Westinghouse Electric Company LLC  
Hematite Decommissioning Project  
3300 State Road P  
Festus, MO 63028  
USA

Subject: Draft Supplemental Response to NRC Request for Additional Information on the  
Hematite Decommissioning Plan Excluding Chapter 11 (License No. SNM-  
00033, Docket No. 070-00036)

References 1 to 11 provided Westinghouse responses to NRC's Requests for Additional Information (RAIs) concerning the Hematite Decommissioning Plan (DP). This letter provides draft supplemental responses to those RAIs where NRC required clarification. These draft supplemental responses are provided in support of the scheduled June 24 and 27 conference calls identified in Reference 12.

Figure 1. Sample Locations along Joachim Creek and Impacted Area

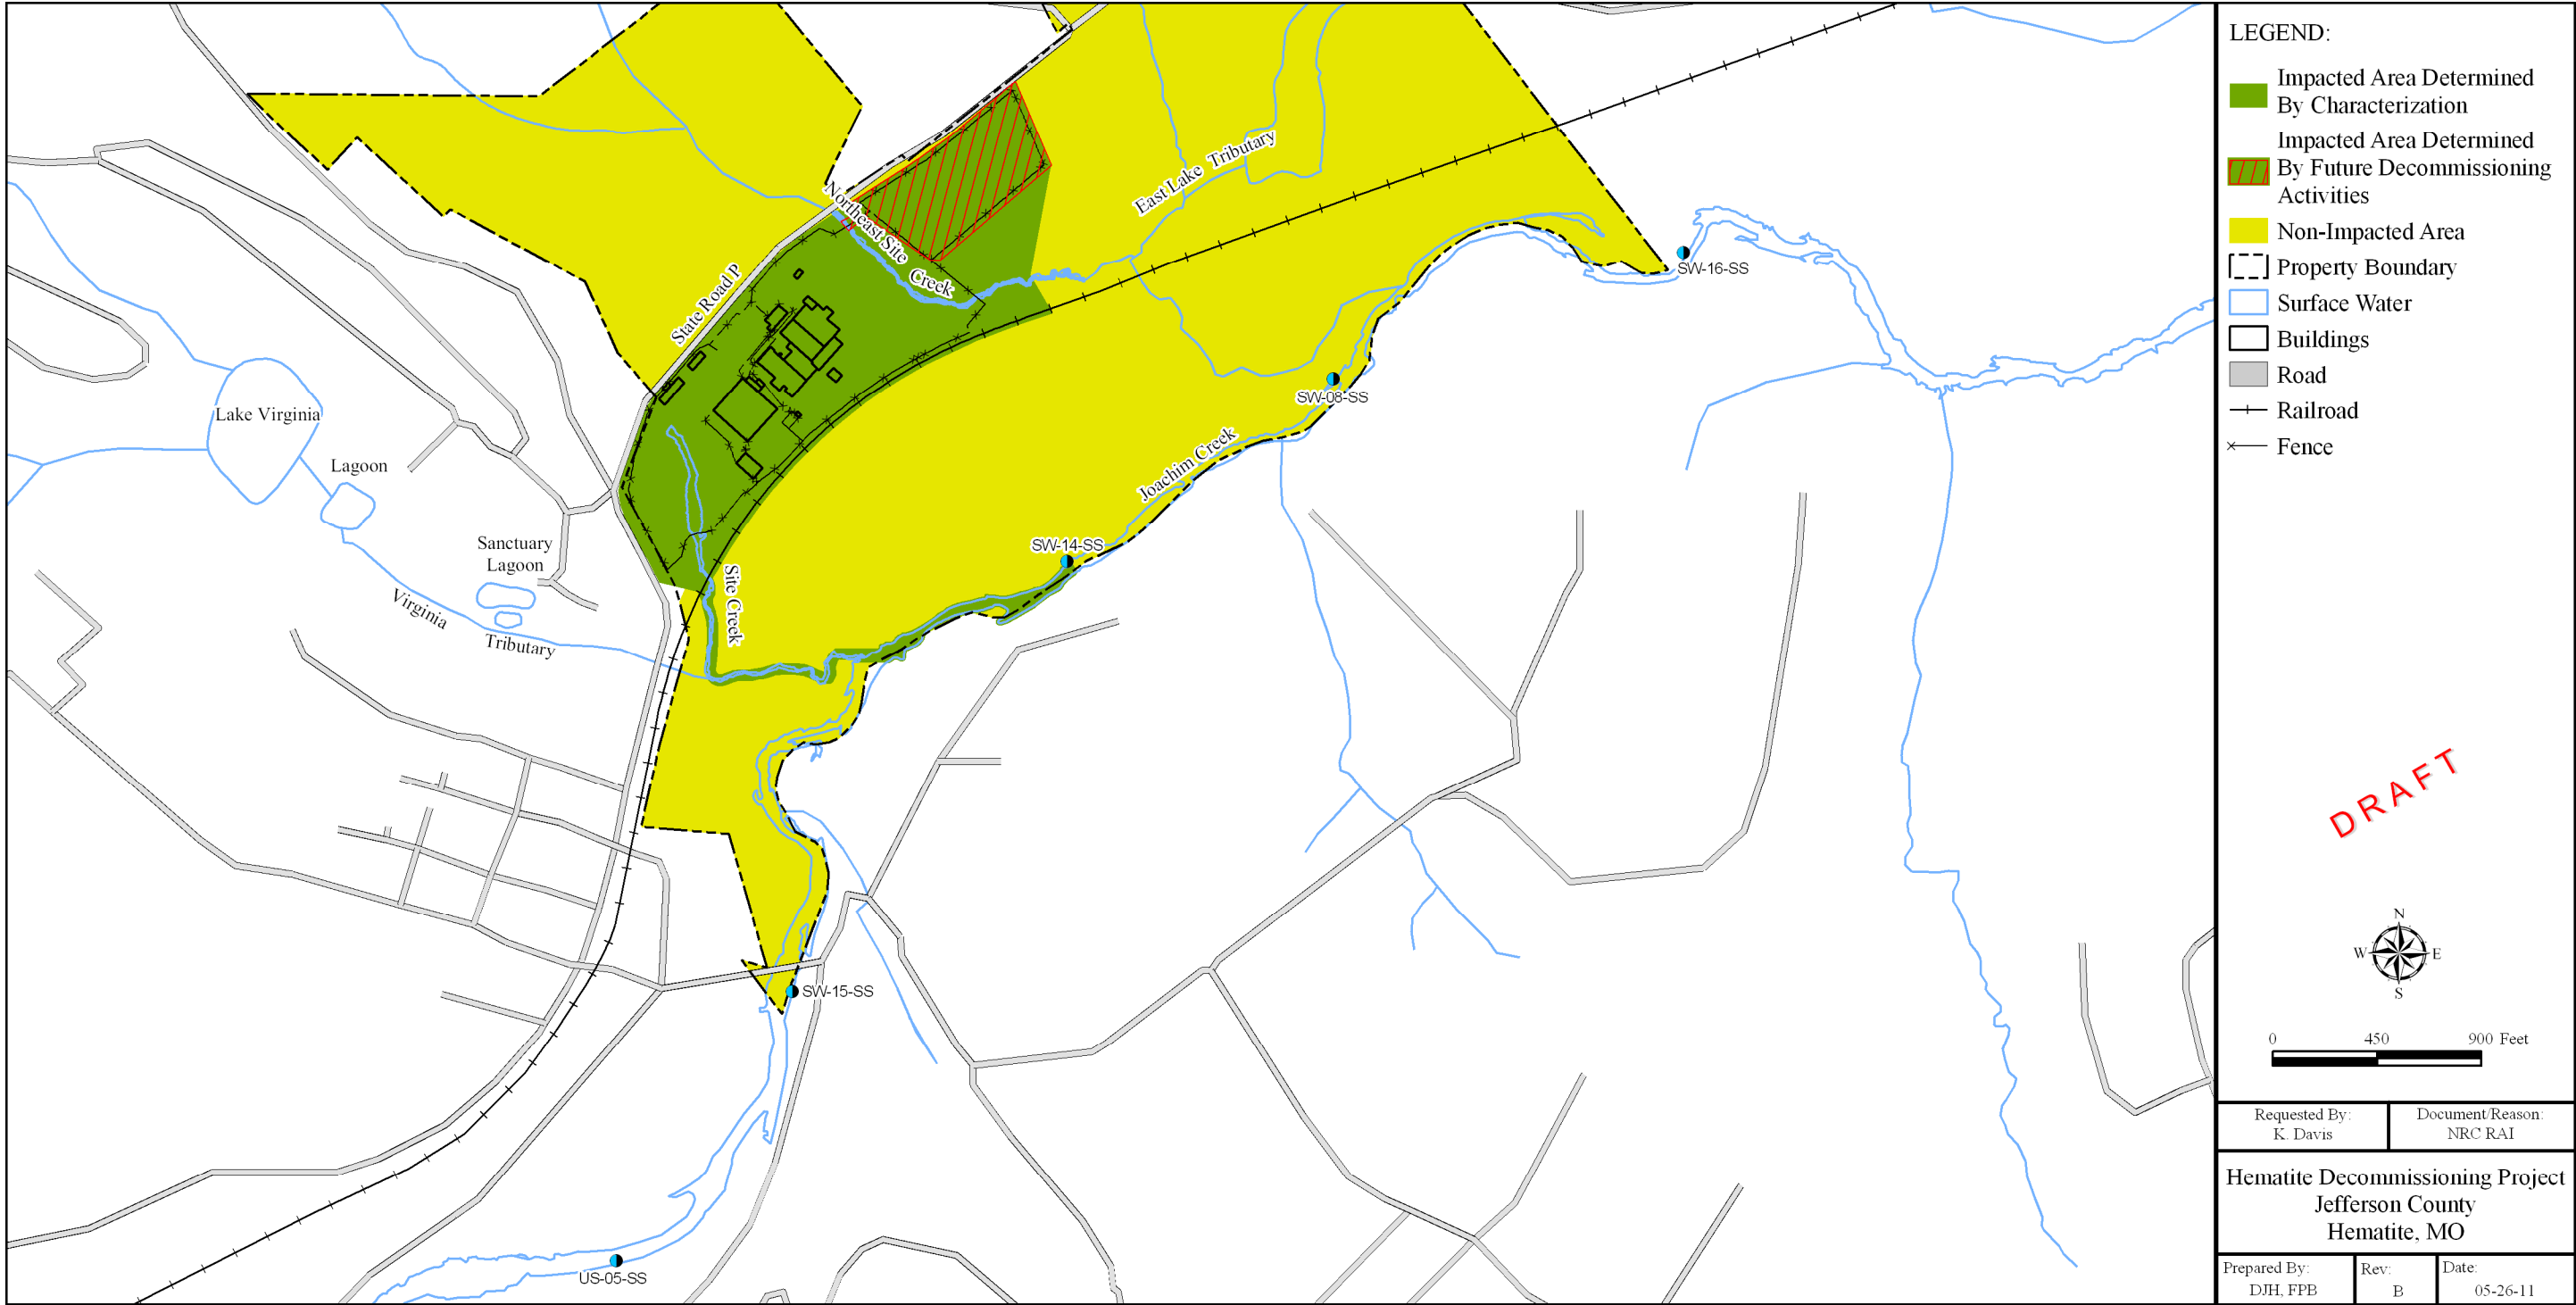
RAI No.	Issues	Path Forward	Discussion Points	Proposed Resolution
14-9c	Consideration of impacted areas on an area by area basis versus a point to point basis.	Westinghouse should clarify their intentions as there are statements in the response to RAI 5-Q1 stating that “Thorium-232 will only be included for demonstrating compliance in areas distinguishable from background or when an individual result exceeds the BTV.” Once areas impacted by Th-232 are identified, Th-232 should be analyzed for compliance purposes in all samples from that area.	Westinghouse believes that this issue was addressed by Westinghouse’s commitment to considering Ra-226 and Th-232 as radionuclides of concern in the identified impacted area at HDP (DP Figure 14-11). Westinghouse will revise the DP to clarify that the presence of both Ra-226 and Th-232 would be accounted for in all impacted areas during final status survey to demonstrate compliance with the dose criteria.	Resolution of NRC comments on DP Chapter 5, RAI No. 1, will also resolve this comment. This comment does not require its own resolution.
